AGENDA MEMORANDUM

Planning Commission Meeting of August 10, 2022

Kingsley Heights

Request for a plat waiver for Off-Road Multi-Use Trail and One Way Cycle Track Construction in Section 3.8.3.C of the Unified Development Code

Exhibit A

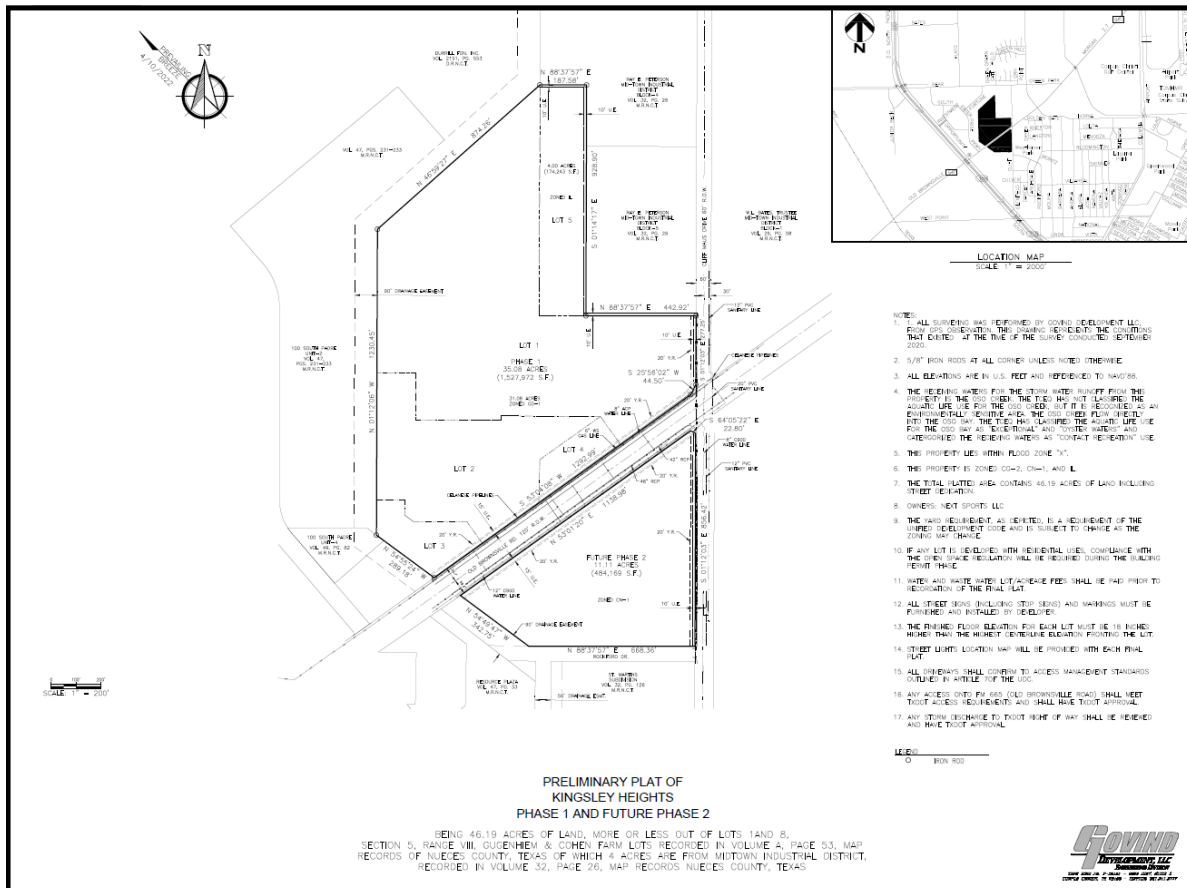
The waiver request is for the construction of 3,240' of an Off-Road Multi-Use Trail running along with the ditch on the left side of the property and the construction of 700' of a One-Way Cycle Track running along the south side of the lot.

2. The Off-Road Multi-Use Trail and the One-Way Cycle Track are clearly defined on the Bicycle Mobility Plan. Not building these tracks will remove the connectivity of bicycle network and future construction of three quarters of a mile that are part of the trail.

5. The drainage ditch berm width is approximately 35 feet and is wide enough that permits the building of the Off-Road Multi-Use Trail.
6. Rockford Dr. (a paper street with utilities) is 50 ft. in width by 600 ft in length and would need to be constructed with the final plat in Phase II of the development. This would require additional dedication of 12 feet of ROW to accommodate the One-Way Cycle Track. The street segment is short and dead ends at the drainage. Staff recommends, in lieu of construction of Rockford Dr. and the One-Way Cycle Track, that the Off-Road Multi-Use Trail be continued within the Rockford Dr. ROW to connect the trail along the ditch to Claud Maus Dr. This would result in cost savings in not constructing a full road section yet providing pedestrian/bicycle access meeting the intent of the Mobility Plan.

- **Disapproval of the waiver** request for the construction of Off-Road Multi-Use Trail and
- **Approval of the waiver request for the construction of One-way cycle track (both sides) with the condition that an Off-Road Multi-Use Trail be constructed instead, and the street construction of Rockford Dr. be waived.**
